## Pending Amendments to Clauses in the Griffith University Design Guidelines & Procedures Version 18

### Edition 18.2

Note: Further amendments to Version 18 not included in the previous Pending Amendments Edition 18.1, are shown in 'green' text

**Diagram 18.i**

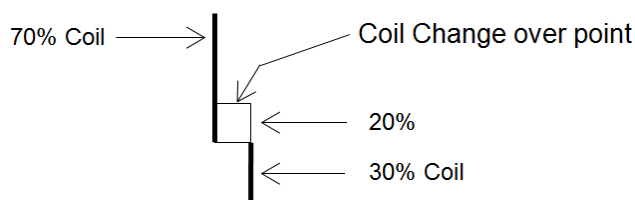
*Delete existing paragraphs and replace with the following;*

- When the load exceeds the 100% capacity of the large coil for more than 5 minutes (adjustable), then the small coil shall be reactivated and the CW flow modulated to achieve the required temperature while maintaining the large coil at full capacity

- If the load requires less than 50% of the cooling capacity of the large coil and the small coil is closed down, then the small coil shall be reactivated and the CW flow to both coils modulated to decrease the capacity of the large coil and increase the capacity of the small coil
- When the load has once again exceeded the 100% cooling capacity of the small coil, then the CW flow control outlined above will commence a new cycle.

The object of this operating strategy is to achieve the maximum amount of cooling required for the minimum amount of the coil cooling capacity available. This will also de-humidify the air and provide the potential to maintain comfort levels while allowing the temperature set point to be raised, with a consequent saving in energy.

**Diagram 18.ii**

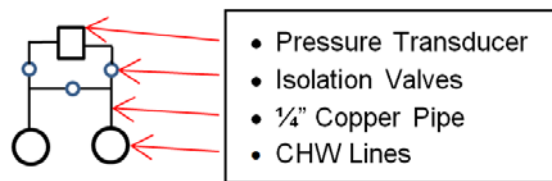
*Insert the following at the end of the existing second paragraph;*

The VSD of any secondary chilled water pump shall be controlled by a pressure transducer located in an easily accessible location at approximately two thirds (2/3) of the distance along the index chilled water pipe run. The pressure transducer pipework shall be configured as shown in the following Diagram 18.ii.

**Diagram 18.iii**

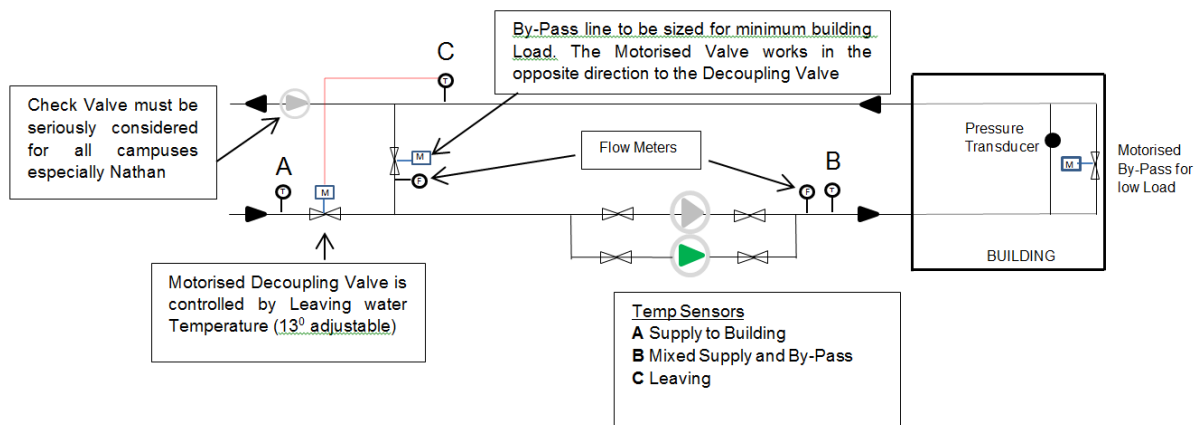
*Insert following new paragraph between the existing fourth and fifth paragraphs;*

**Secondary Chilled Water Pipework Layout** – The supply and return pipework within a building, shall incorporate the secondary pipework and control/monitoring valves and equipment as shown on the following Diagram 18.iii to maintain consistent water flows and temperature control throughout the building pipework system.
